New Albany Architectural Review Board Meeting Agenda
Monday, January 13, 2025 7:00 p.m.

New Albany Architectural Review Board
Monday, December 9, 2024 Meeting Minutes - DRAFT

Plan

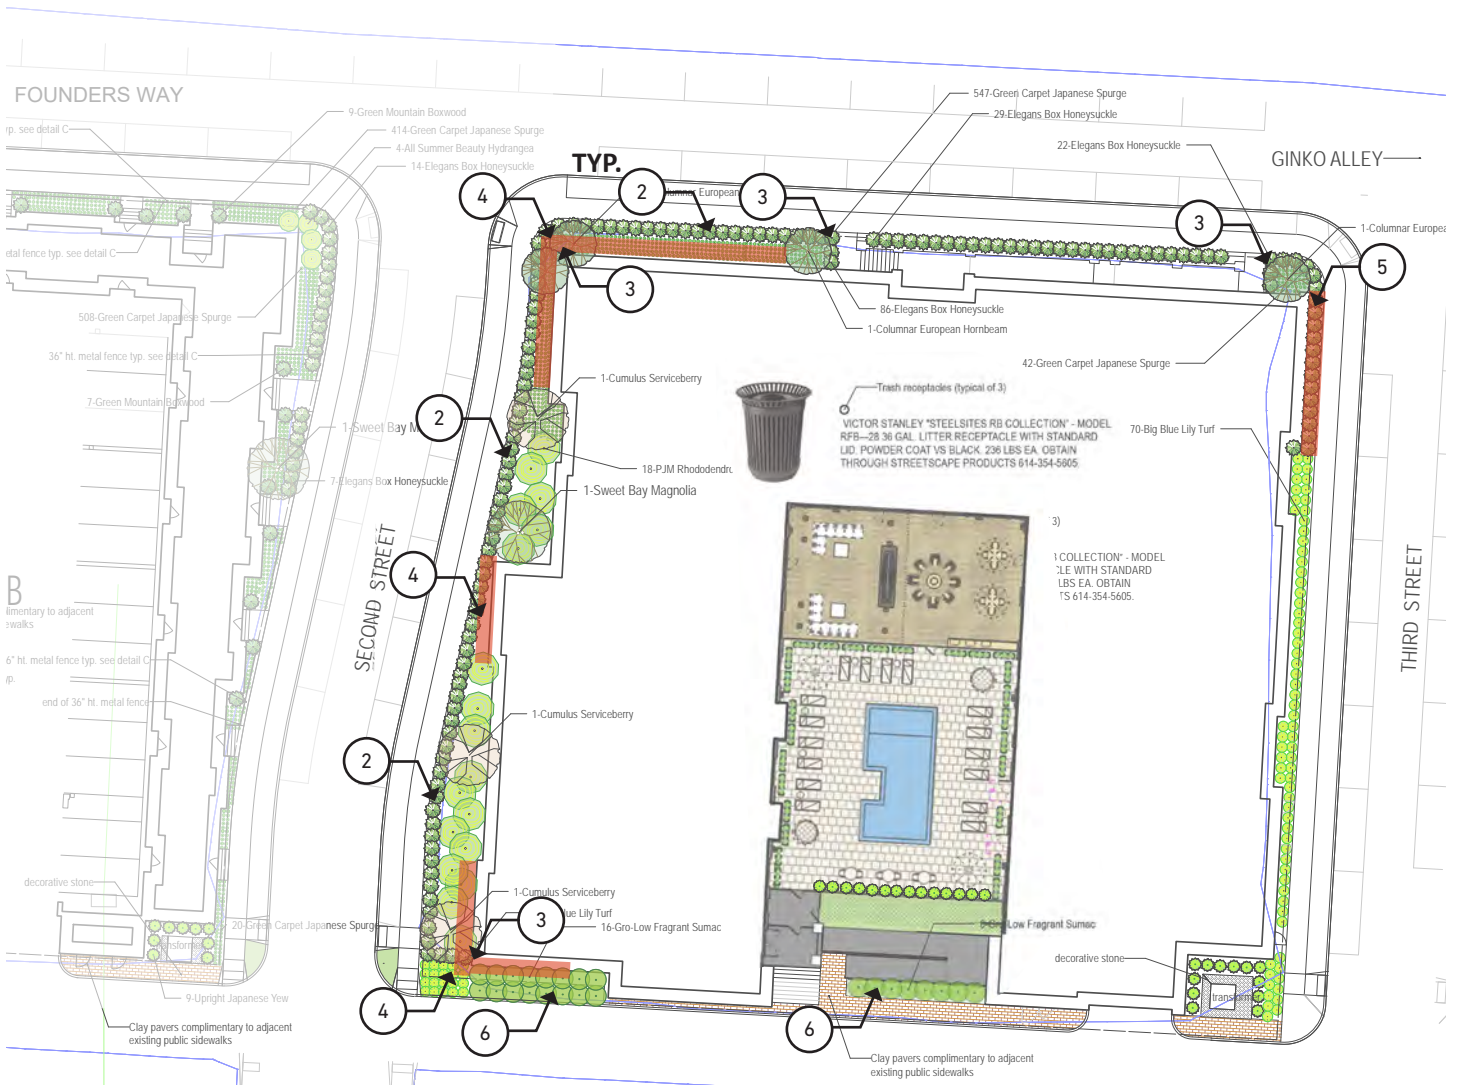
1. Update plant list to properly represent proposed materials, typical all. Resubmit updated plan for review.
2. Revise the proposed placement of Elegans Box Honeysuckle around the exterior of Building C, allowing for the material to be set from the sidewalk and removed in strategic locations to avoid the visual of a continuous hedgerow. See below.

3. Revise the proposed landscape treatment around the exterior of Building C to include an increased use of evergreen plant material at strategic focal points along the facade. See below.
